BOARD OF ADJUSTMENT MEETING AGENDA

1. (VAR-Fields at Pinnacle) A request by James Dibble for Fields at Pinnacle requesting to a variance from Section 14-732, U-COM/U-NBT Residential Transition Standards requiring an 8' masonry screen wall along the property line at 5501 W. Madison Avenue in the U-COM (Uptown-Core Mixed Use) and the U-NBT (Uptown Neighborhood Transition) zoning district.

Vin Hotel Masonry Wall

HOTEL VIN FIELDS AT PINNACLE LOT 3

Site Plan

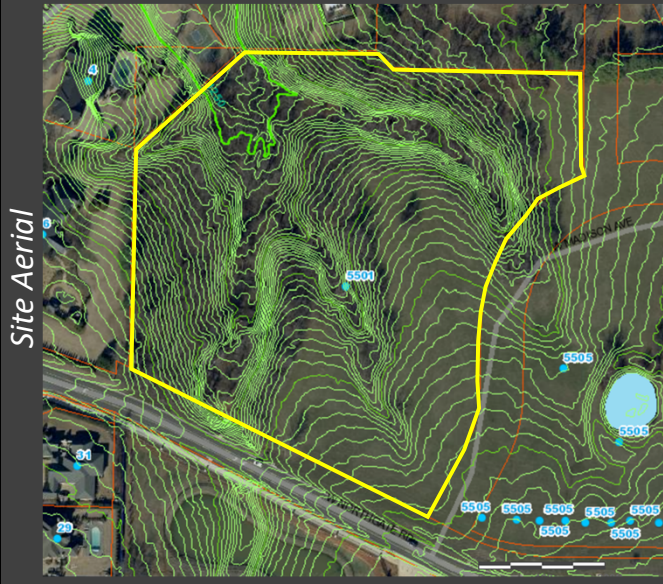
Not particularly. Strict enforcement of the code would require the applicants to build an 8' masonry wall along their western/northwestern property boundary that abuts existing single-family uses. A significant amount of mature trees would have to be removed as a result of this requirement. This is not necessarily a site-specific hardship, unique to this property.

<p>How is the spirit and intent of the code being met?</p>	<p>The forested area west of the hotel serves as a substantial visual buffer for the adjacent single-family homes. The terrain of the site also slopes, somewhat drastically, to the northwest. Because of the proposed preserved vegetation, steep slope of the property, and the required placement of the 8' masonry wall, the wall wouldn't block the view any better than the existing mature tree cover would for the adjacent neighbors.</p>
<p>Can the difficulty be obviated by some feasible method other than a variance?</p>	<p>No. The difficulty in this instance is the requirement to construct an 8 foot tall masonry wall that runs nearly 800 linear feet along the western and northwestern property boundary.</p>

- No. The difficulty in this instance is the requirement to construct an 8 foot tall masonry wall that runs nearly 800 linear feet.

APPROVE the variance request to waive the masonry wall requirement with following conditions:

- An easement or similar legal instrument to preserve 25' bufferyard along property line adjacent to existing single-family uses, that contains existing or new canopy trees at a rate of 2 per 50 linear feet.
